Title of Change:	SO16 Package Polyimide Tape Change.
Effective date:	14 Aug 2020
Contact information:	Contact your local ON Semiconductor Sales Office or LengKian.See@onsemi.com
Type of notification:	This Product Bulletin is for notification purposes only. ON Semiconductor will proceed with implementation of this change upon publication of this Product Bulletin.
Change Category:	Assembly Change
Change Sub-Category(s):	Manufacturing Process Change

Description of Change (From) :

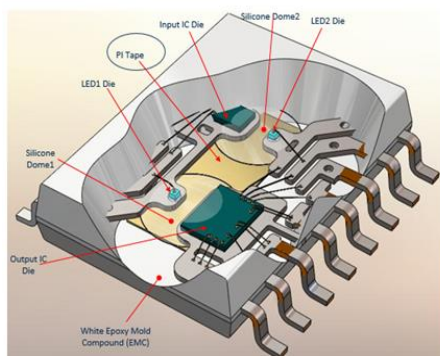
Type A polyimide (PI) tape within the package.

A new improved type B polyimide (PI) tape within the package.
